[Docket No. 2002-SW-38-AD; Amendment 39-12935; AD 2002-22-10]

Airworthiness Directives; Bell Helicopter Textron Canada Limited Model 407 Helicopters

ACTION: Final rule; request for comments.

Figure 1. Pre-Flight check of brackets, horizontal stabilizer slats.

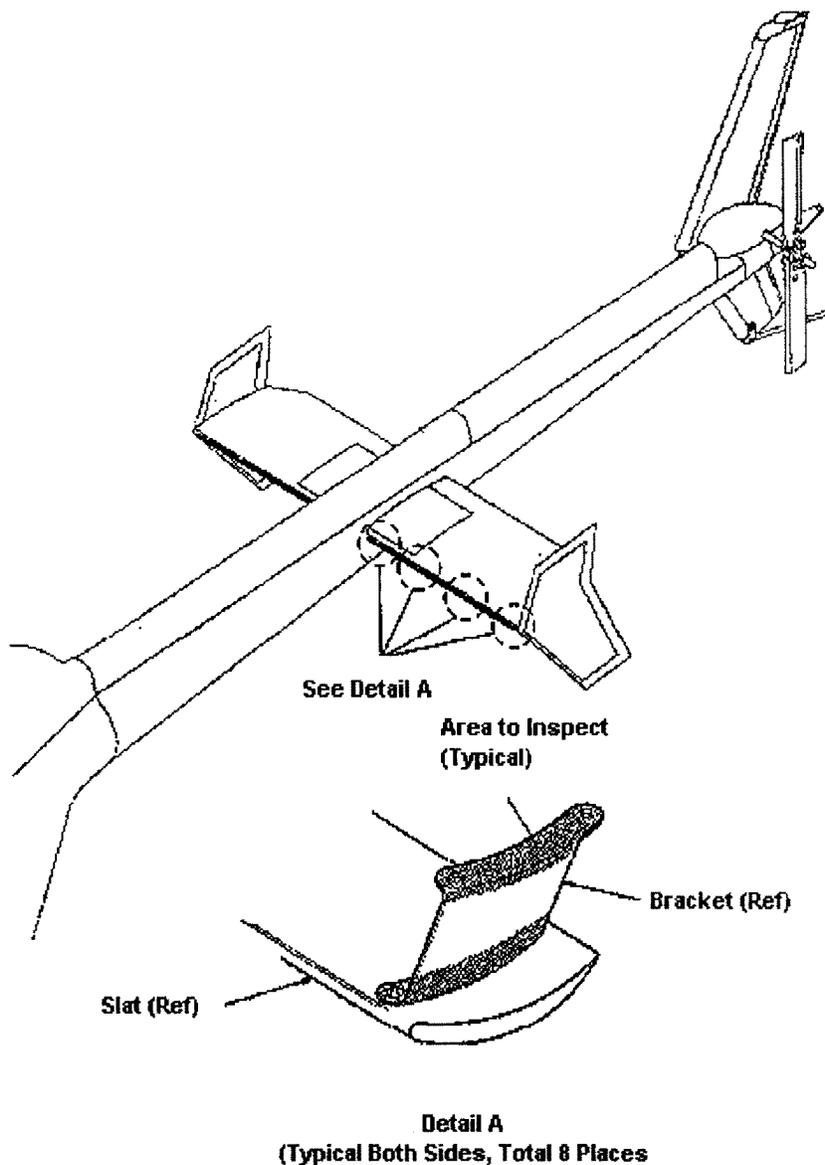
(1) Within 10 hours time-in-service (TIS) and thereafter before the first flight of each day, check each slat for a crack at the radius

of each bracket, part numbers (P/N) 206-023-119-109, -110 or 407-023-801-127, -128, or

407-023-001-119, -120, or -121, as shown in Figure 1 of this AD:

(3) If a crack is found, before further flight, replace slat assembly, P/N 407-023-002-117 or 407-023-001-101, with an airworthy, segmented slat assembly, P/N 407-023-001-103.
